Shearwater Petrel 1 & 2/Perdix/Perdix AI/NERD 2 Firmware v59 Release Notes

VERSION 59 2018.07.06

Shearwater Petrel 1 & 2/Perdix/Perdix AI/NERD 2 Firmware v53 Release Notes

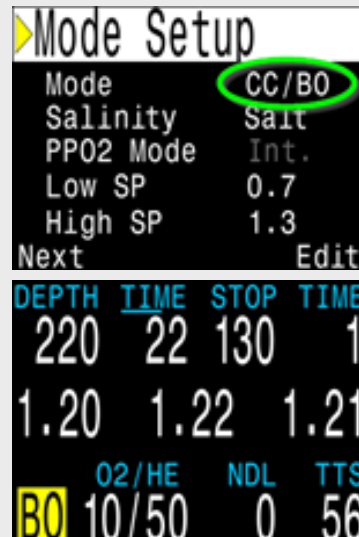
- FIX** Now able to add the $\Delta+5$ to the configurable center row locations. This was mistakenly omitted from v34 on the Petrel 1 model only.

The tissues bar graph is now shown on the Tissues Restored screen

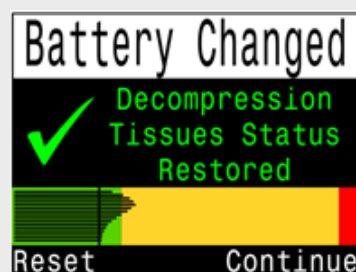
NEW After changing the battery, the current deco tissue loading is shown on the Tissues Restored screen.

NEW On the Tissues Restored screen, a shortcut to reset the tissues is given. If Reset is chosen, a prompt will be displayed to confirm. **Do NOT reset tissues between repetitive dives, as inert gas loading will be lost.**

The offset between current and marked heading is now shown (in this example 16°)

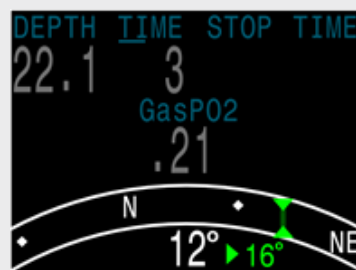
IMPROVE When a heading is marked, the display now shows the offset angle between the current heading and the marked heading. This is useful for navigating patterns. For example, a box pattern requires turns at 90° intervals, while a triangle pattern requires turns at 120° intervals.

On the “Bus Devices” page, choose “View” to see more info and settings

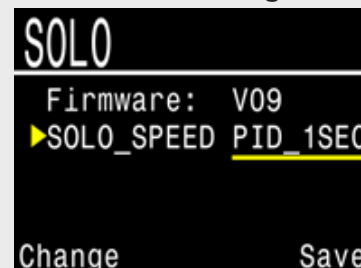
NEW Added support for changing settings on peripheral boards.

For example, on the SOLO board (solenoid and oxygen controller) the Solenoid Speed setting can be adjusted. Go to “Bus Devices” page on Petrel to access peripheral boards. Settings viewed here are stored on the peripheral device.

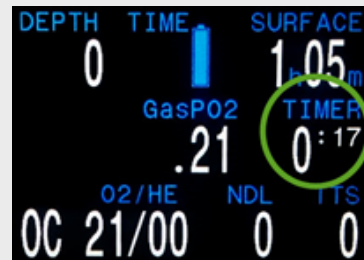
The current compass numerical value (azimuth) is shown on the “Mark Heading” menu.
